MORIN BUILDING
8570 EXECUTIVE PARK AVENUE
FAIRFAX, VIRGINIA 22116-0815

Subject: Addendum # 2 to IFB #18-53, Lee Highway Transmission Main

**IFB No. 18-53
PROJECT 2545, DIVISION 2
LEE HIGHWAY TRANSMISSION MAIN**

12" Interconnection "F" Δ
Scale: 1"=10' Horz. ; 1"=10' Vert.
(See Sheet 13 for Plan View)

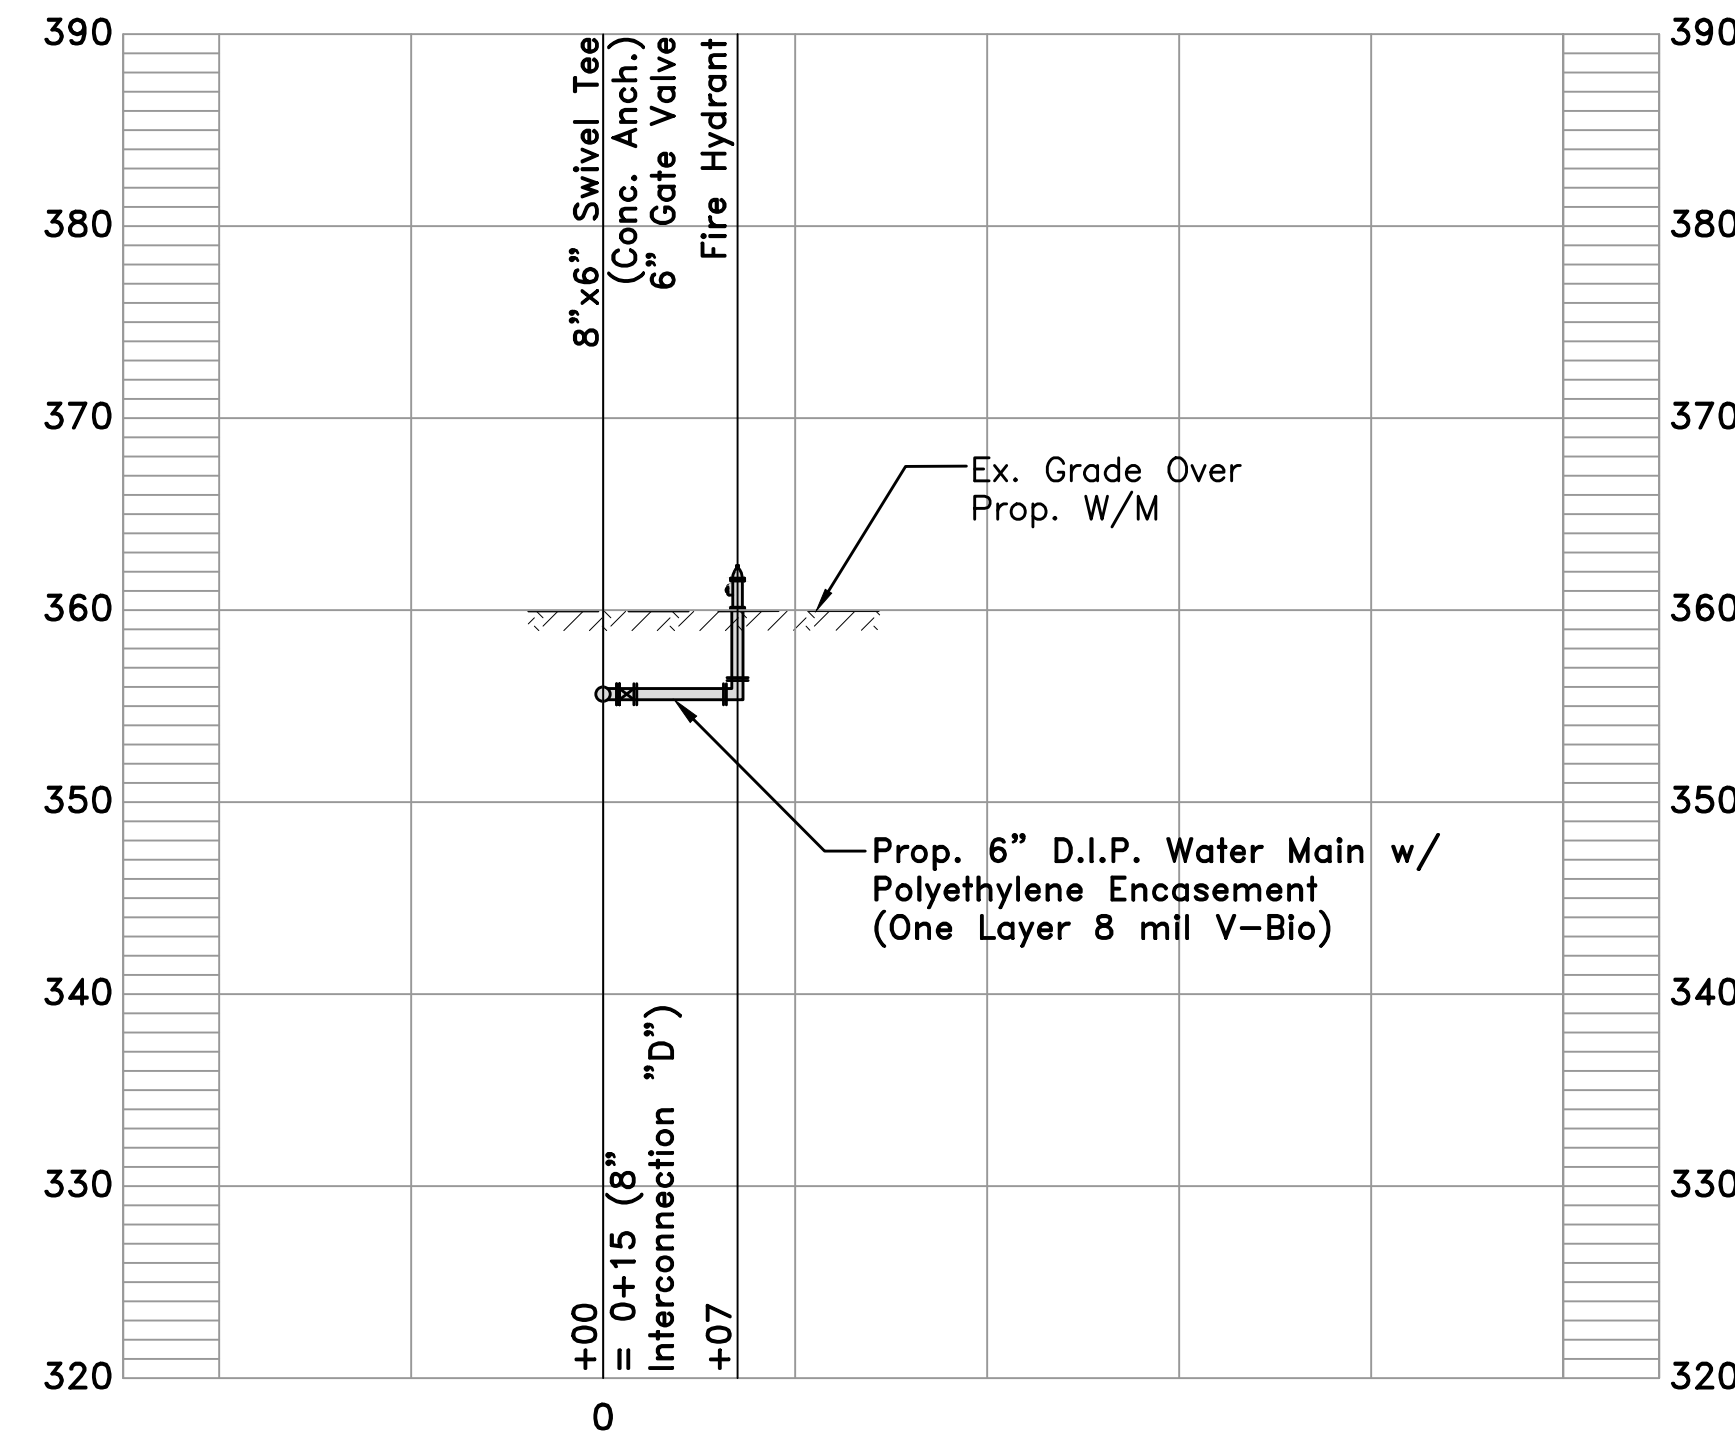
A. *Limits of proposed pavement restoration on private properties is required as indicated in the Contract Documents.*
2. Drawing 13 has two interconnections that are both labeled as Interconnection "E". Profile Drawing on Sheet 30 has the 12" Interconnection "E" at 117 LF and Sheet 30A has it at 17 LF. Which is correct?

FAIRFAX WATER PLANNING & ENGINEERING DIVISION	DESIGNED: PA	 6/27/18	Addendum No. 2 – Revised Name Of 12”
	DRAWN: MAR/SRB		Interconnection “E” To “F”
	CHECKED: RSQ		
		NO. DATE

A. *This matter is addressed in this Addendum.*

PROJECT	DIVISION	JUNE 2018
2545	2	SHEET
		35
TAX MAP 50-1, 50-3		Of 54

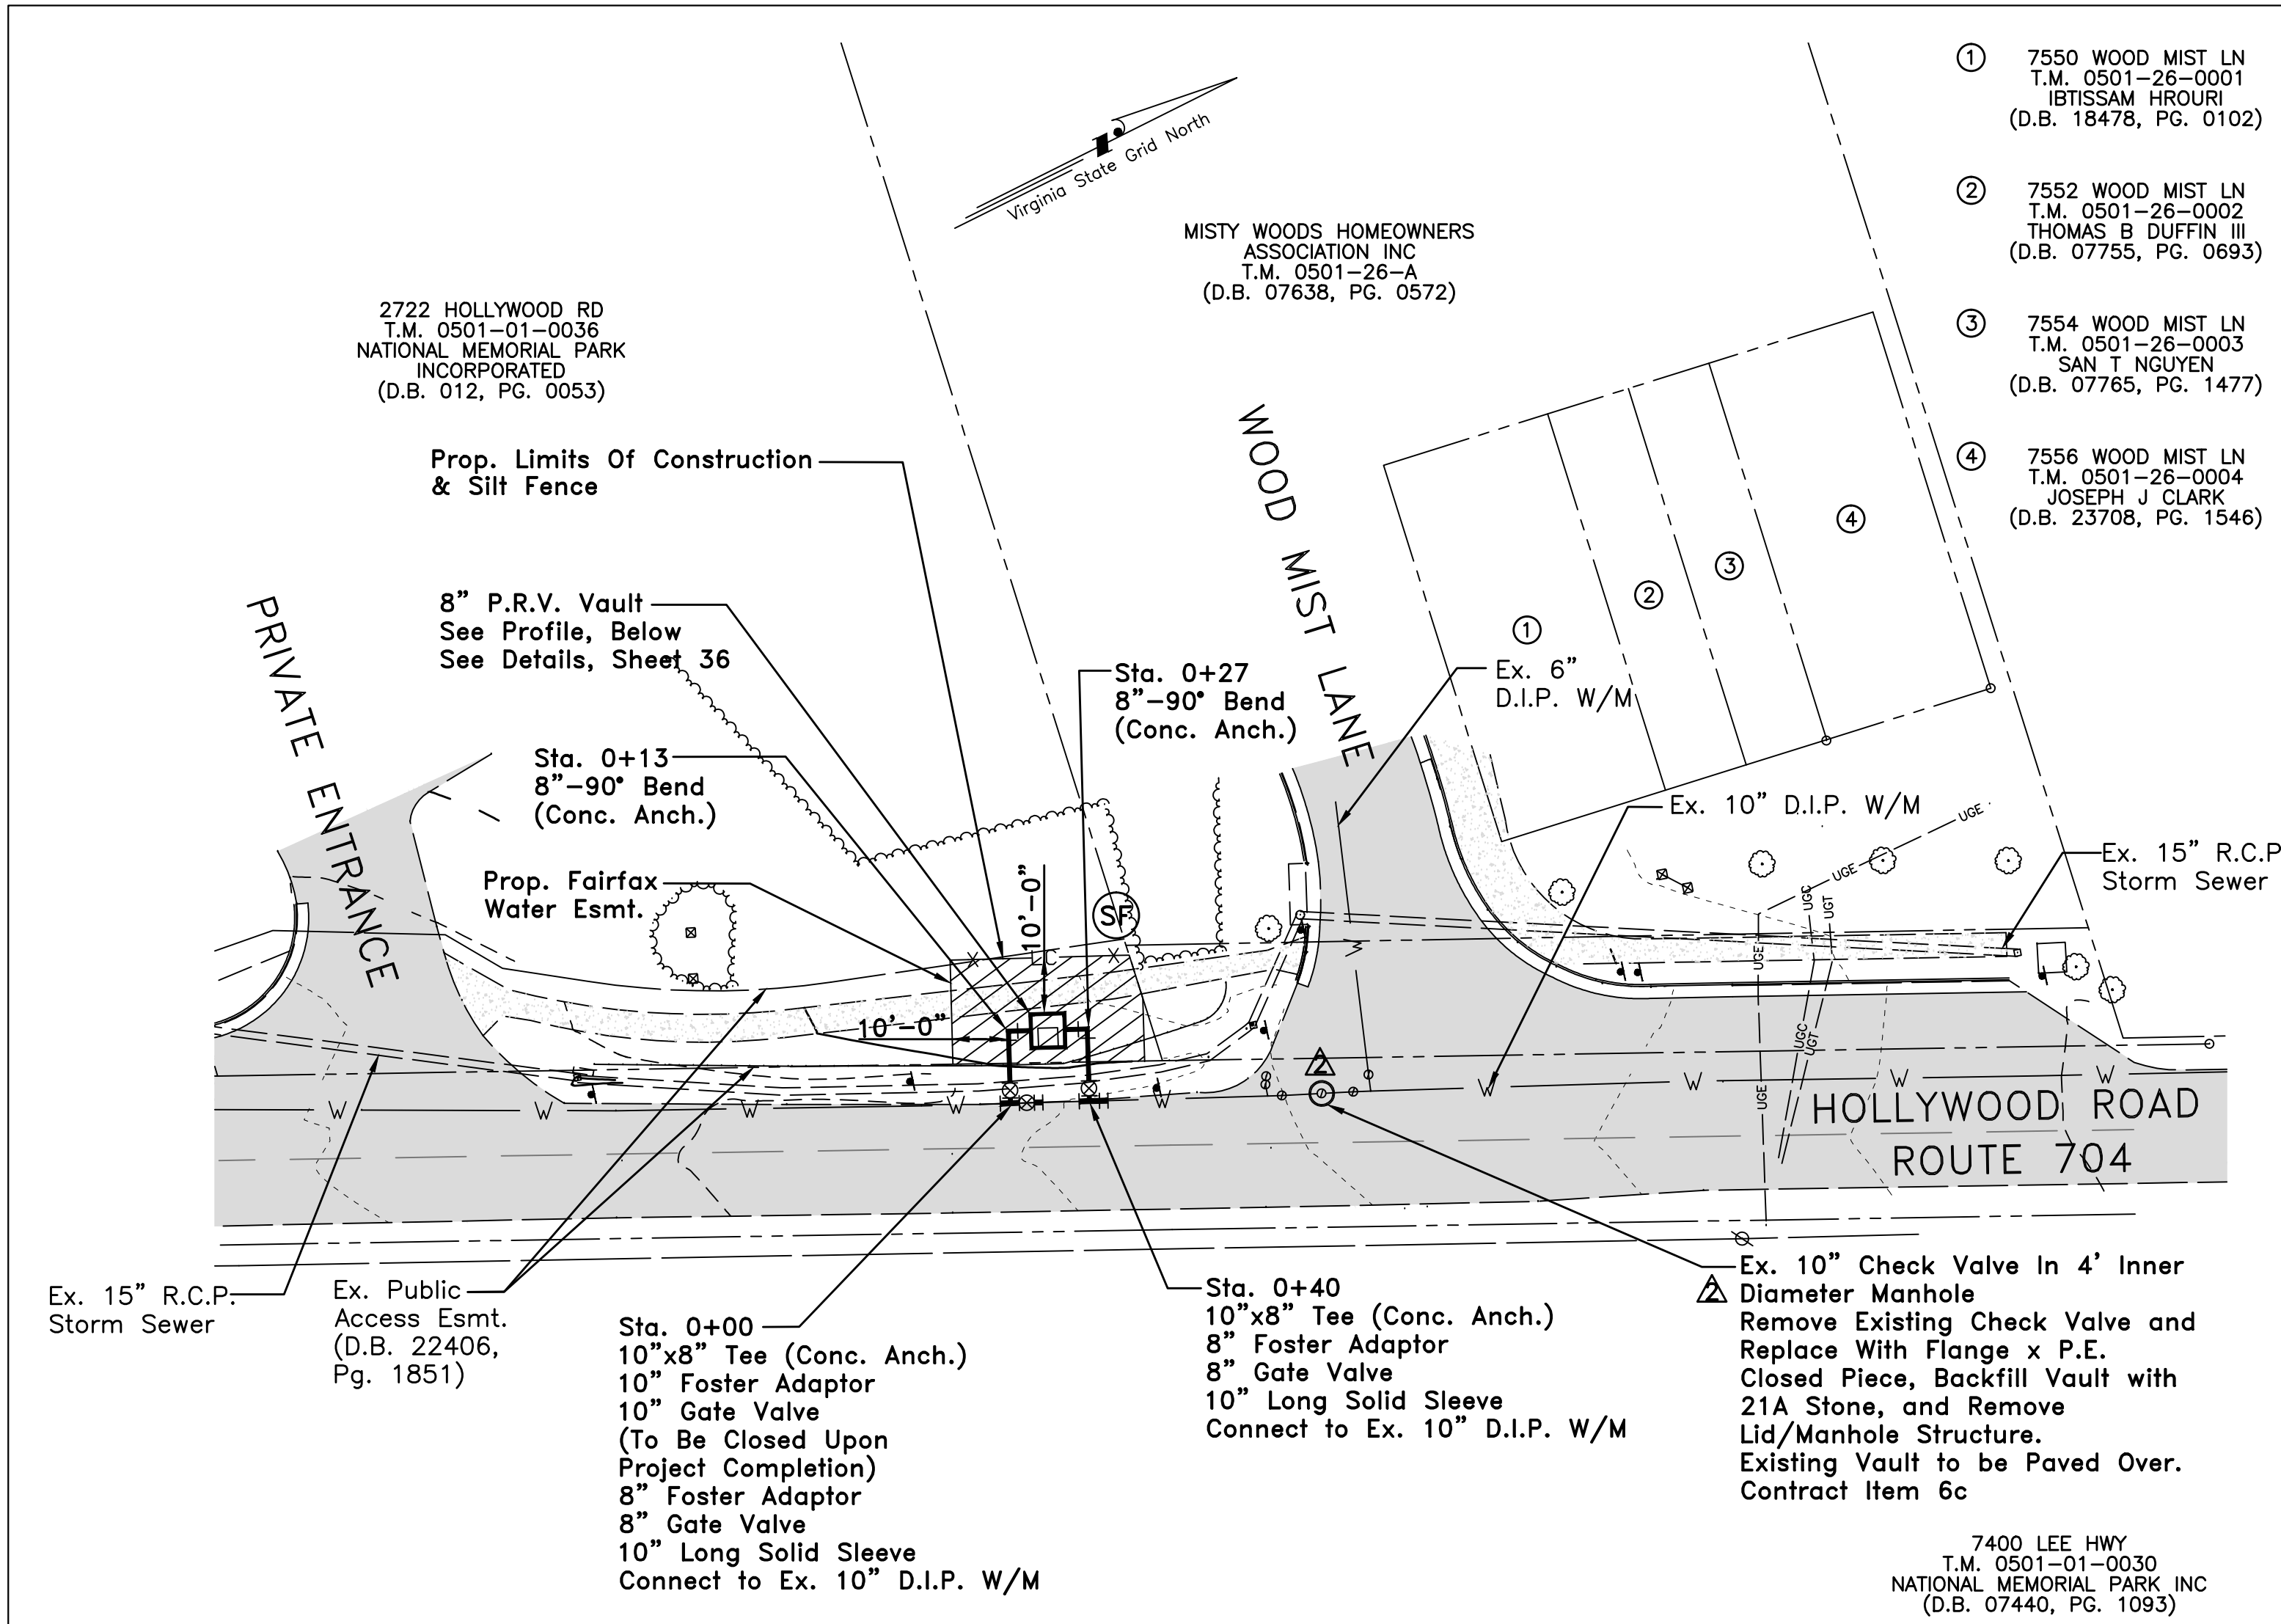
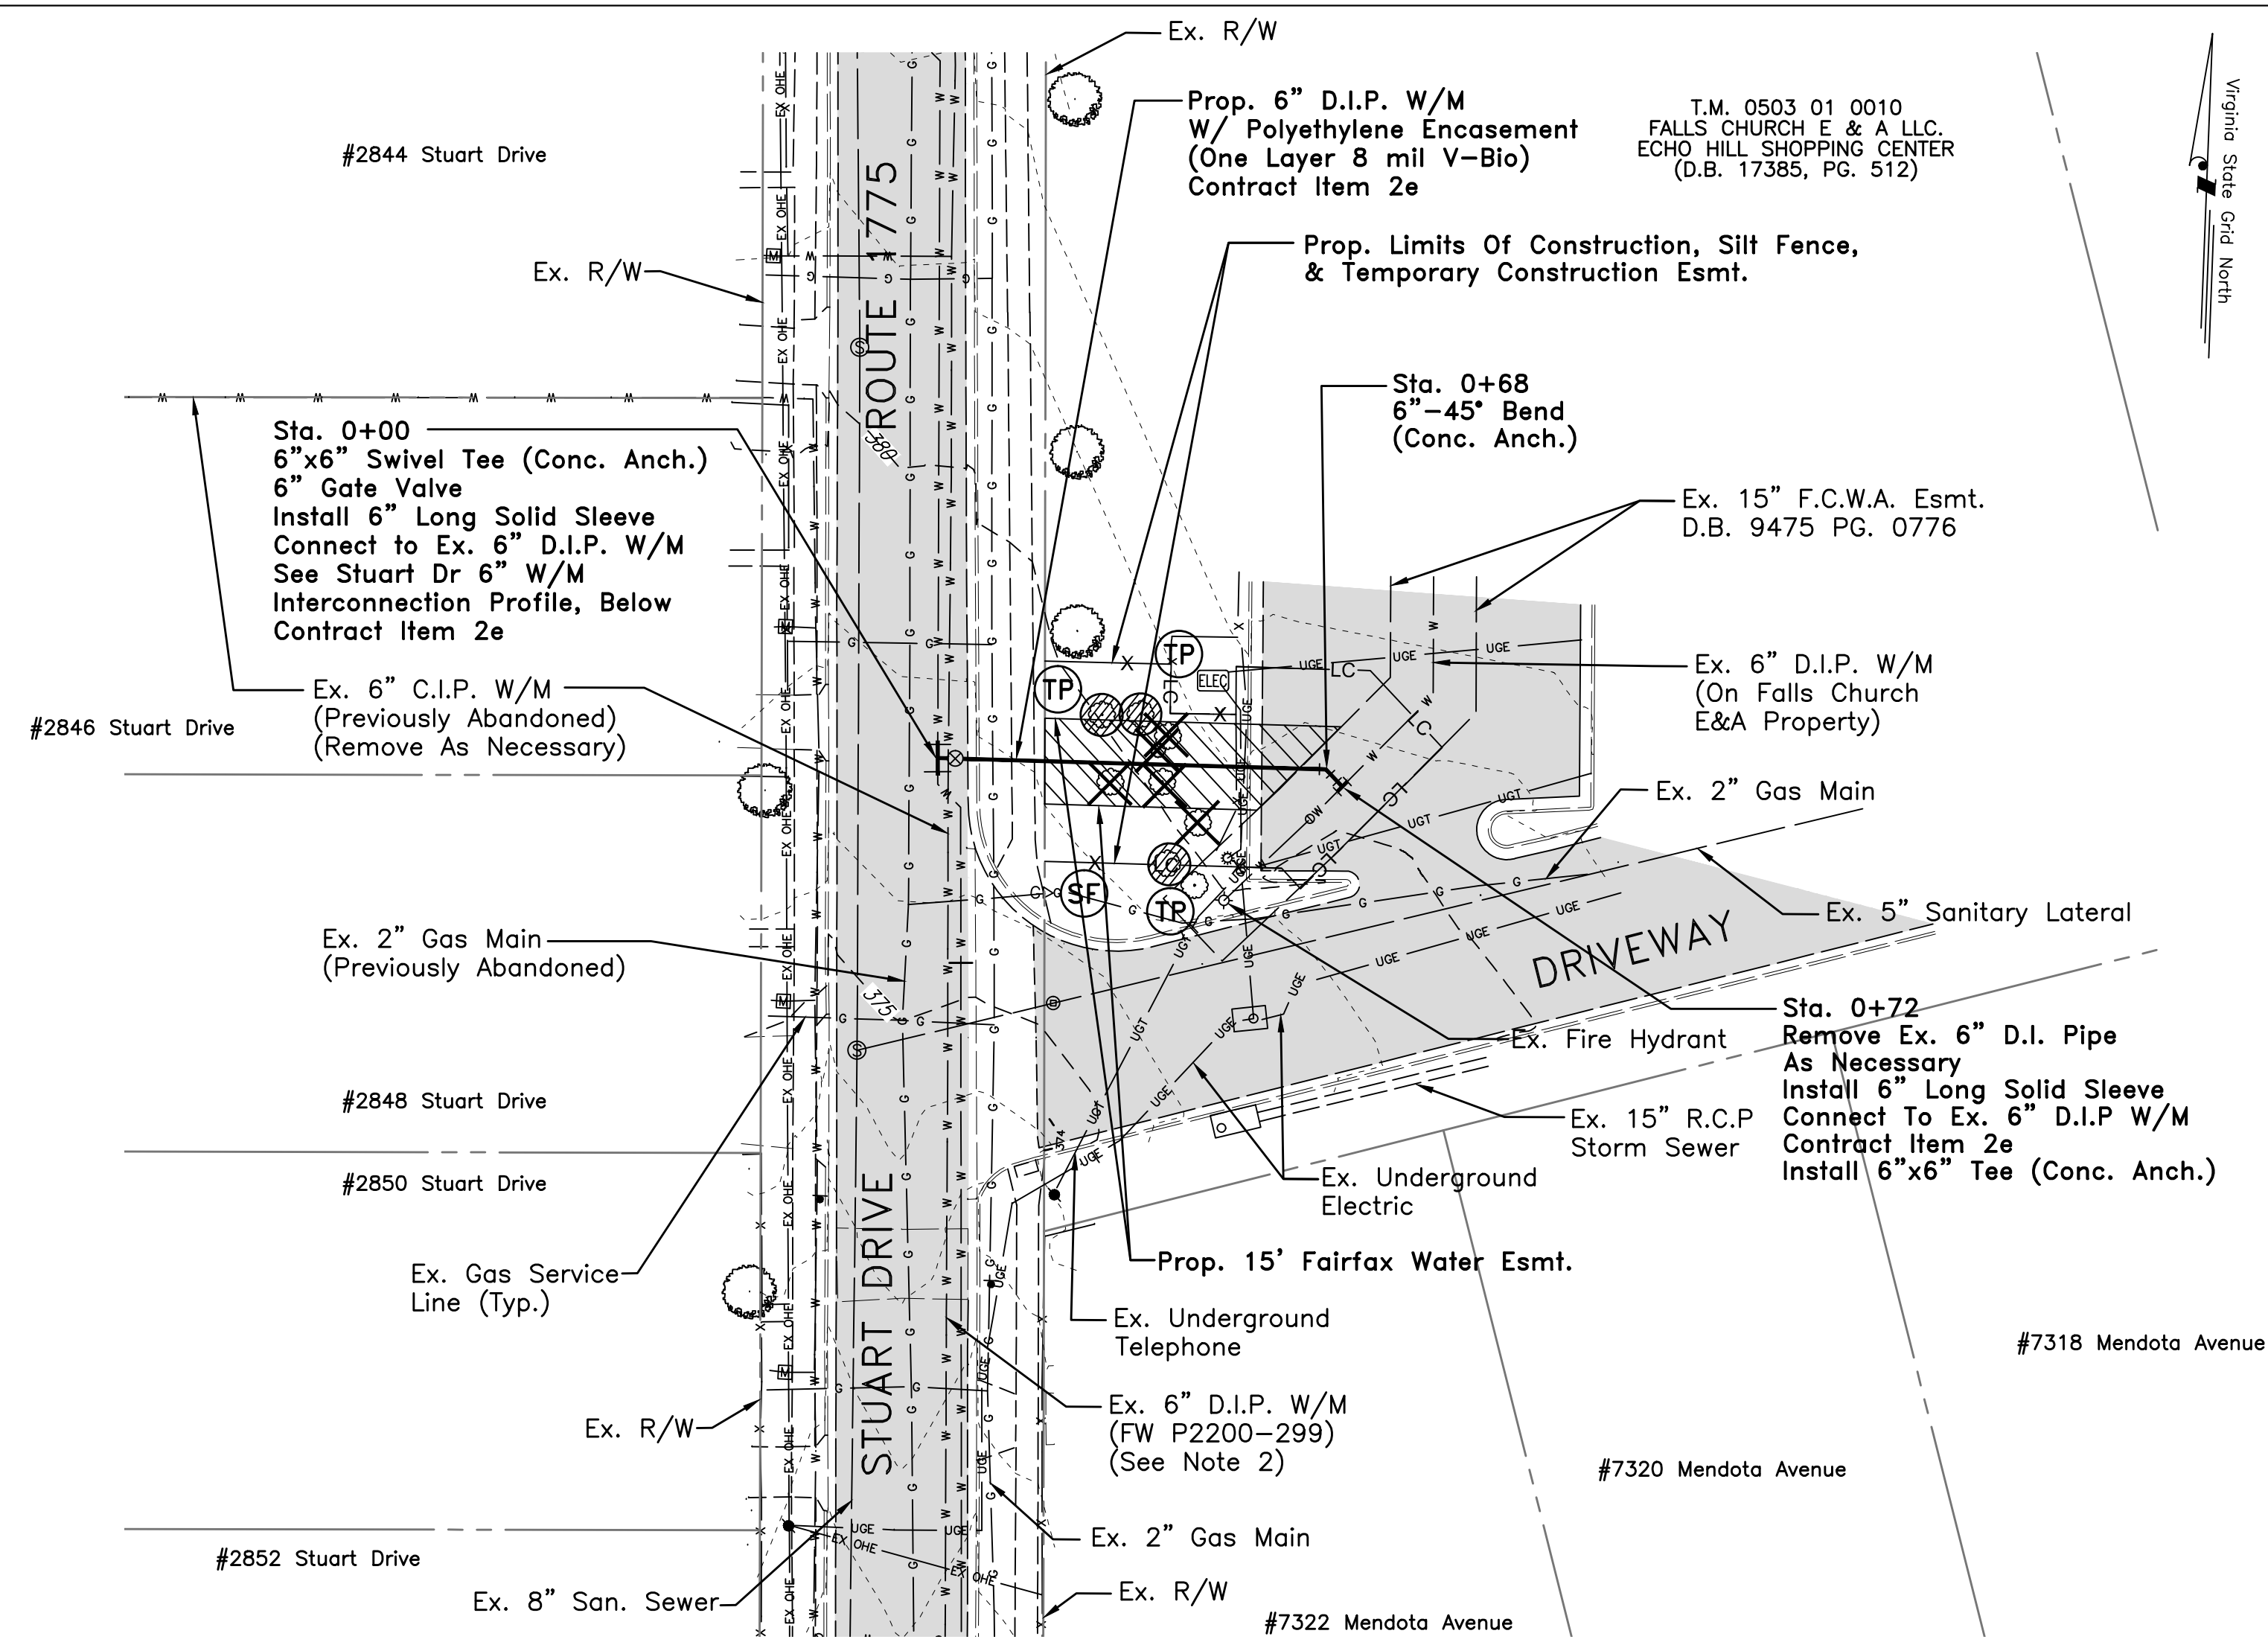
6/27/18	Addendum No. 2 - Added Ex. Check Valve Vault Dimensions
NO.	DATE
